Re: Arborwalk East Multi-Family Development - Comment Response Narrative

Below describe the applicants comment responses (in red) to the comments.

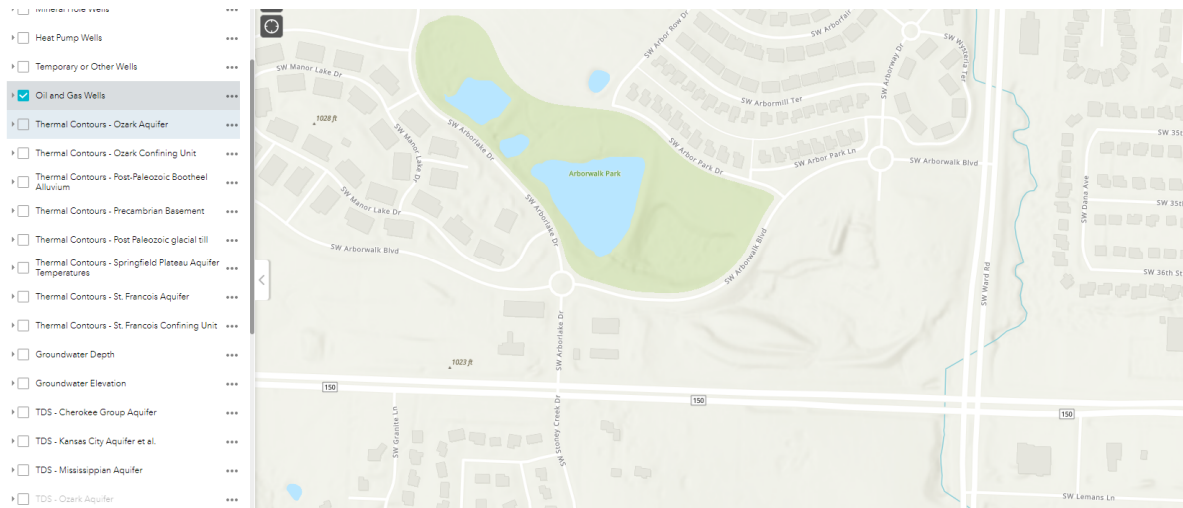
Comment 1: Please visit the Missouri Department of Natural Resources at <https://dnr.mo.gov/land-geology/geology/oil-gas-resources> to identify if any oil or gas wells are present on the property. If none are present please update the note on sheet C1 stating there are no wells present per MO DNR.

Response: **Sheet C1 adjusted to note that no wells are present per MoDNR. See screenshot below from MoDNR:**
